Project number: 20004
Prepared by: Helen Jenkins/Andy Roberts
Subject: Comments on proposed development at land off Capel Street, Capel-le-Ferne
Date: 15th January 2020 **File no:** 20004.D1a

1.1.1 This technical note has been produced on behalf of Capel-le-Ferne Parish Council to comment on the proposals for 34 residential dwellings off Capel Street (between Nos. 107 to 127). Lime Transport's experience and the qualifications of this report's authors are included at the back of the report.

Swept-path analysis - large car
accessing the private driveways
(sheet 1 of 2)

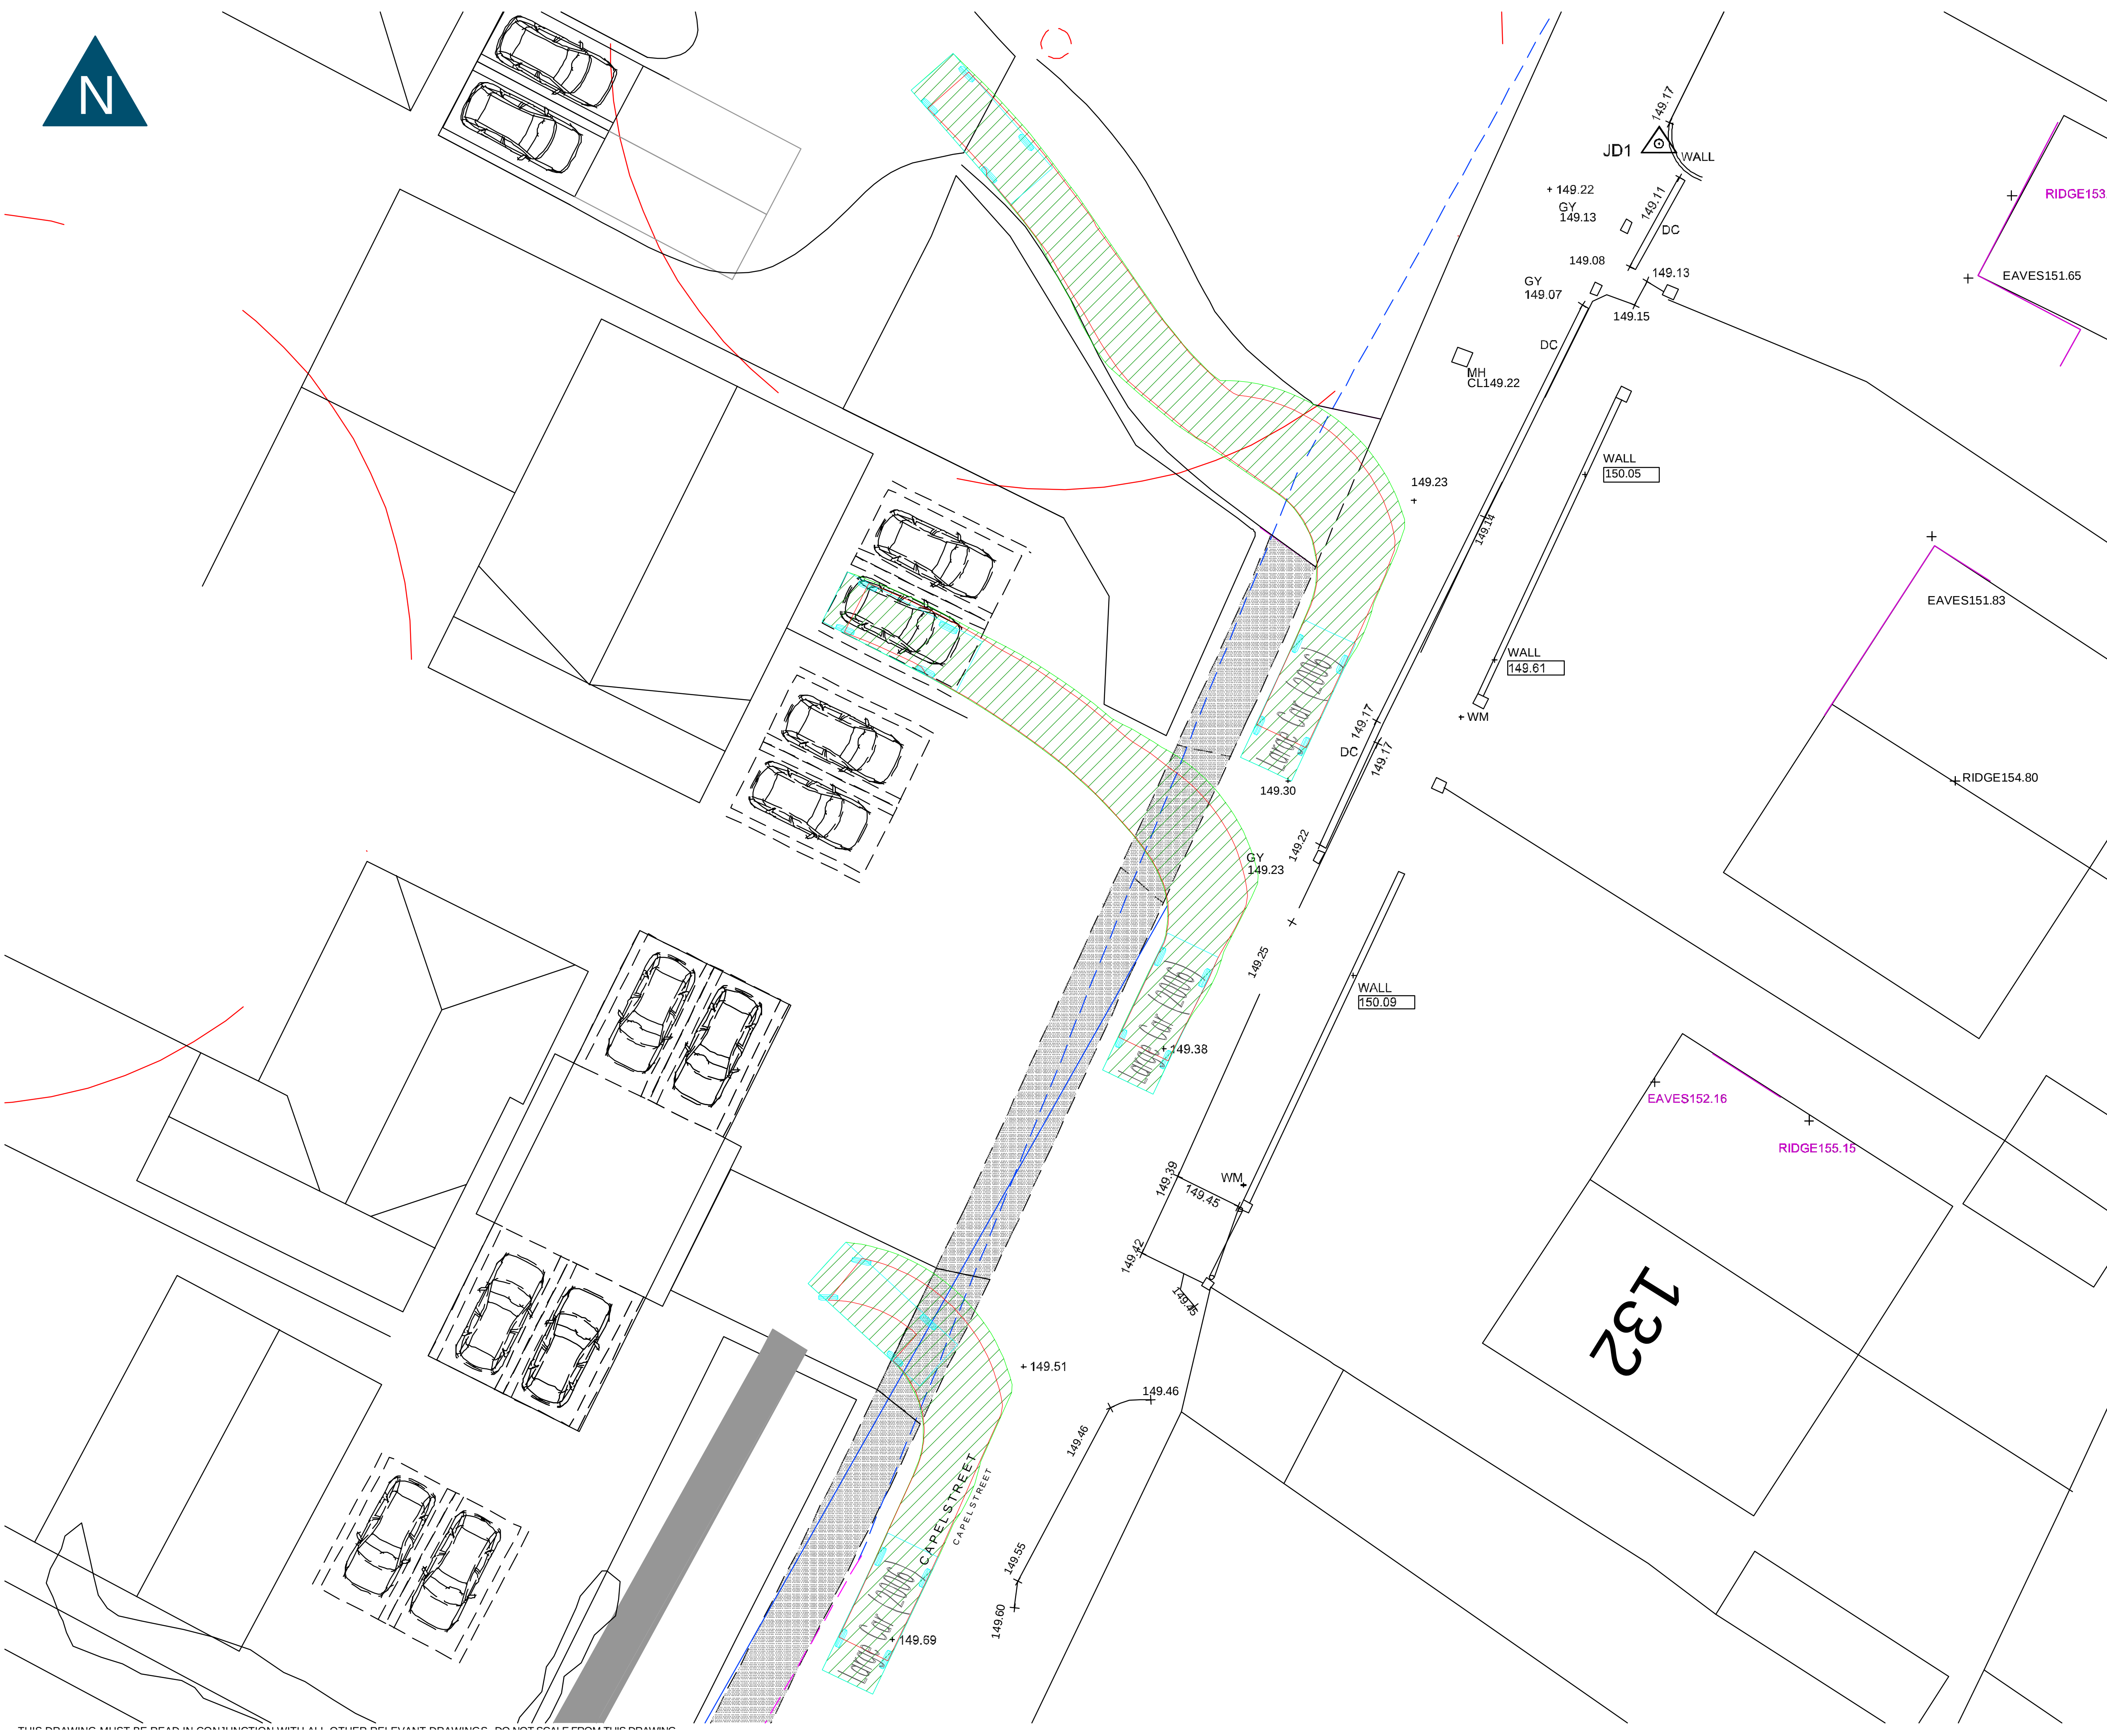
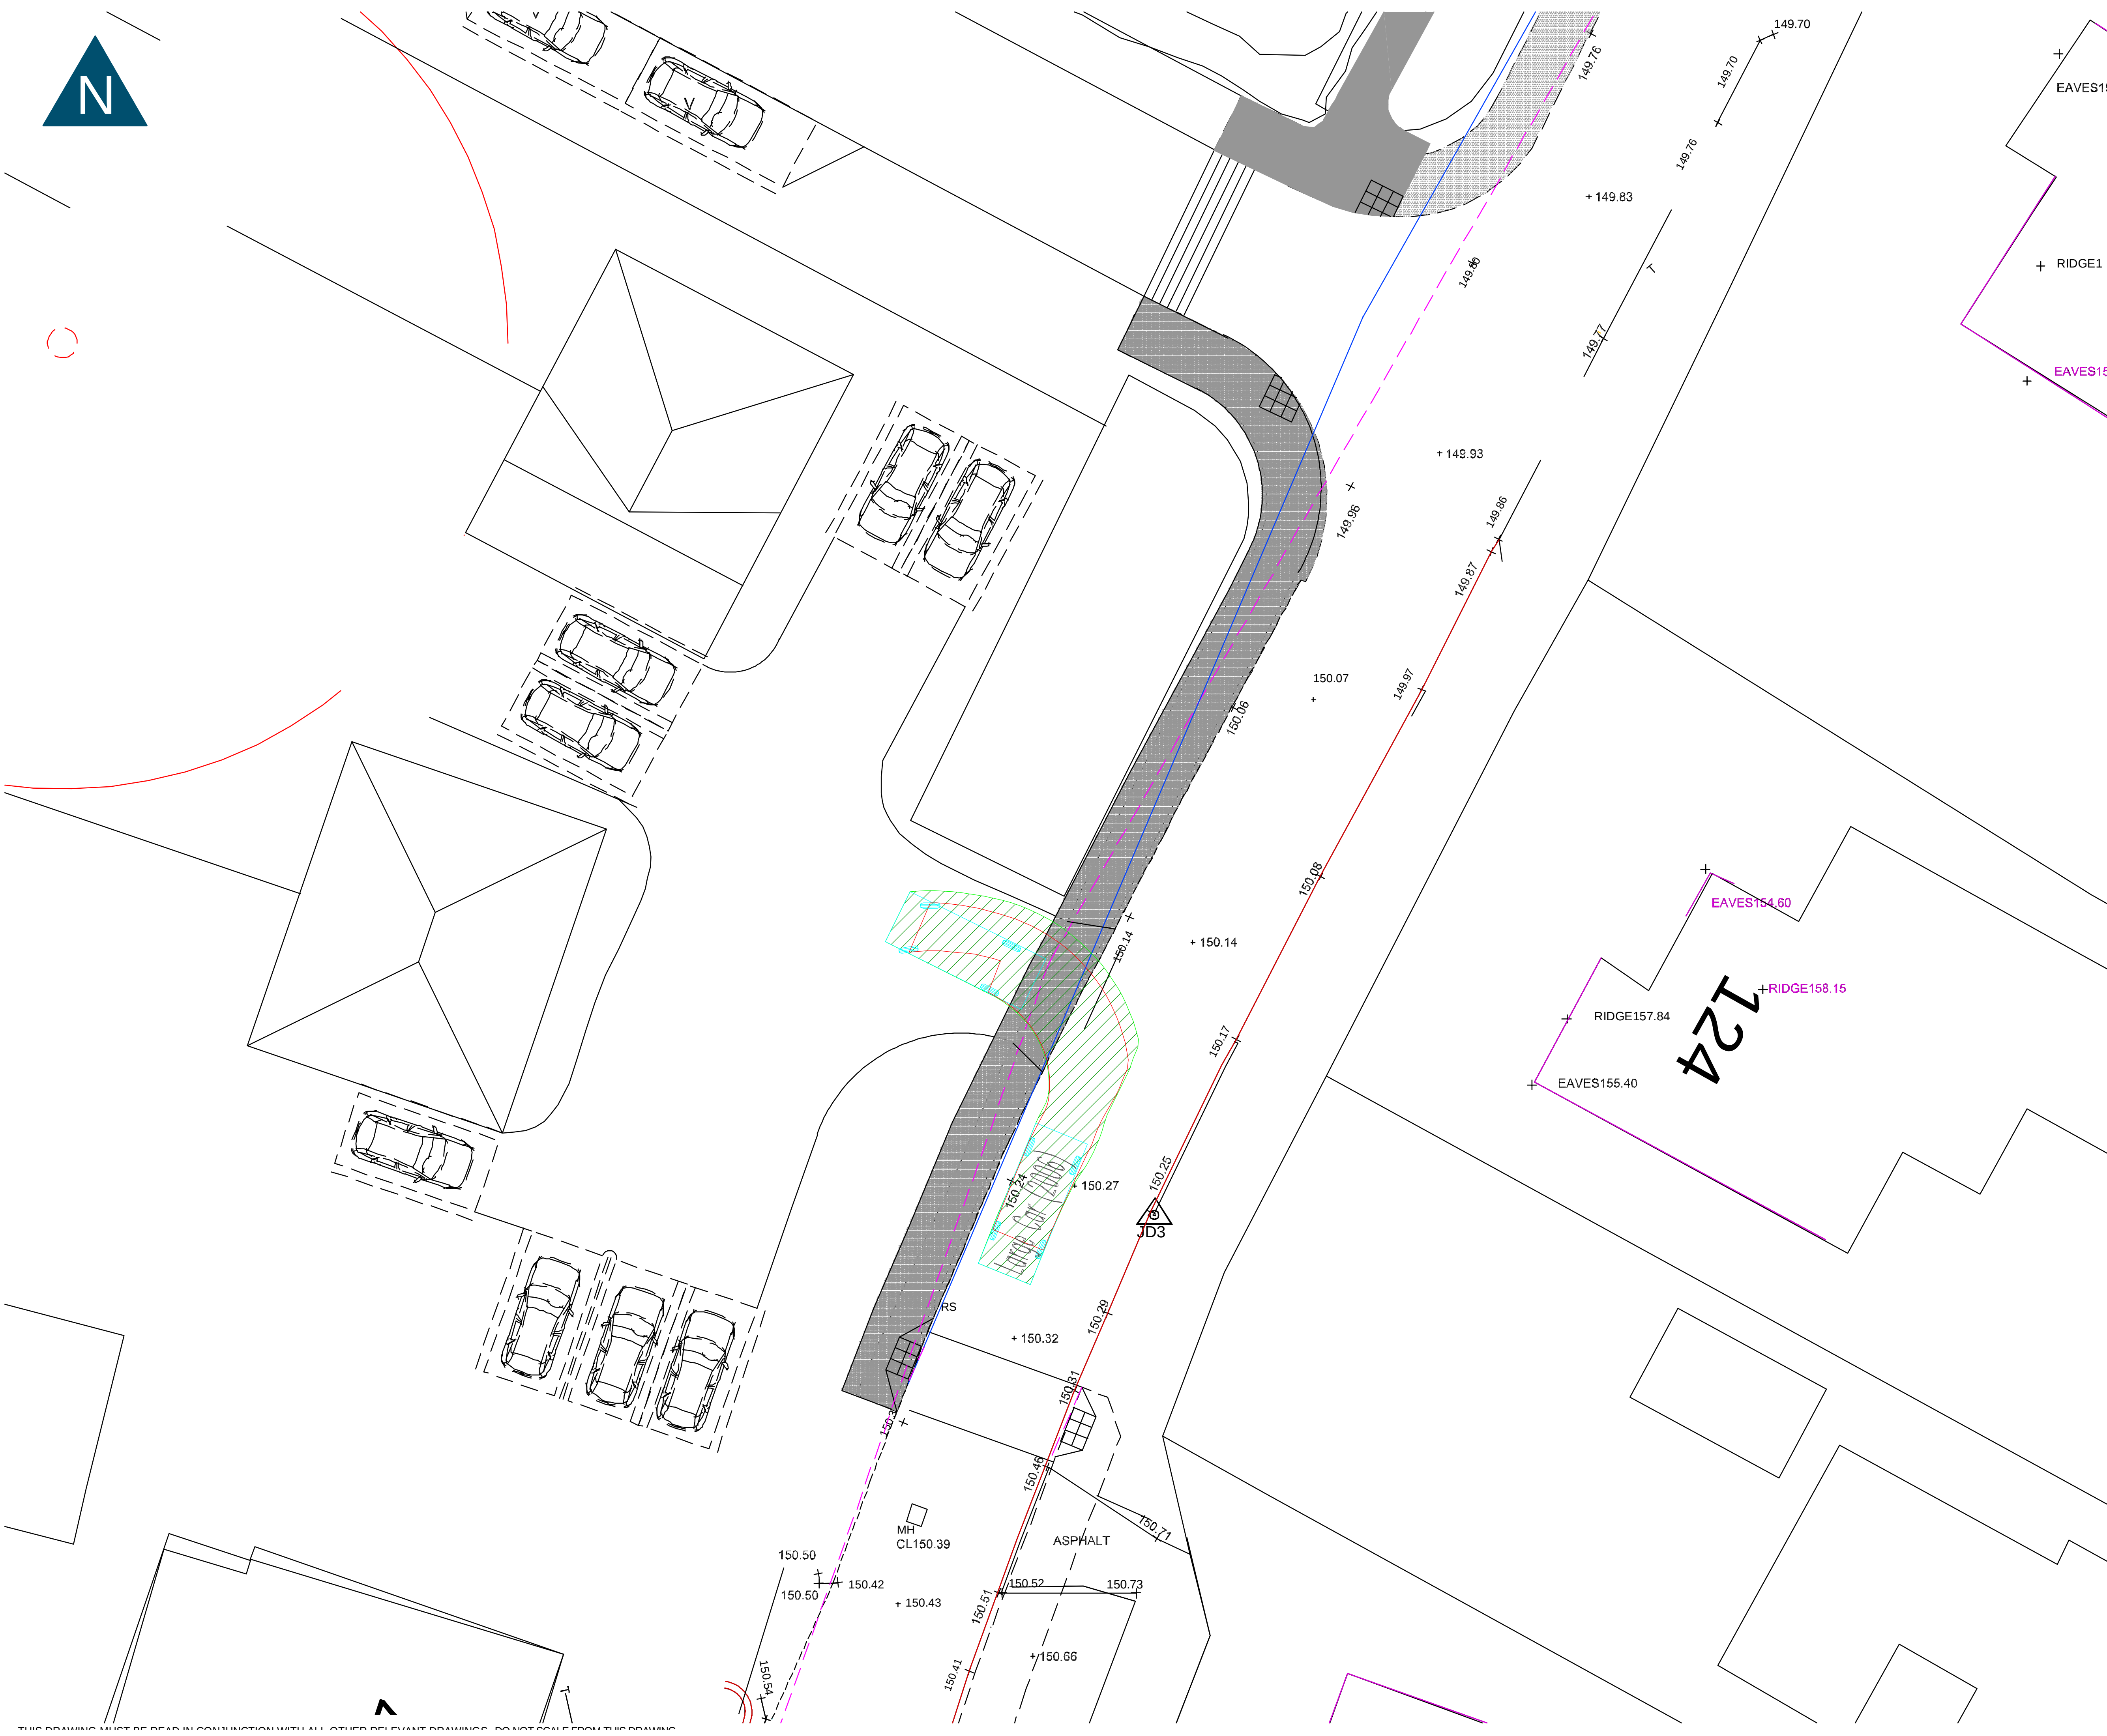
2.5.9 In addition, there are no swept-path analyses for any of the shared private drives onto Capel Street, to demonstrate that a large car can access or egress the site without sweeping on to the opposite side of the carriageway, conflicting within a vehicle travelling in the opposite direction of the drive. Swept-path analysis undertaken as part of this review demonstrates that a large car requires the full width of the access at each of the shared private drives (see drawings 20004.TOPO.101.04 and 05). Forward visibility for vehicles turning into these drives is particularly an issue given the proposals to replant the hedgerow.

2.5.10 It is also considered that the layout as shown on the Illustrative Masterplan does not show sufficient space within the shared private driveways, particularly the central two private driveways, to allow a car to enter and exit the driveway in a forward gear. This increases the potential for accidents along Capel Street. None of these manoeuvres have been shown on any swept-path diagrams.
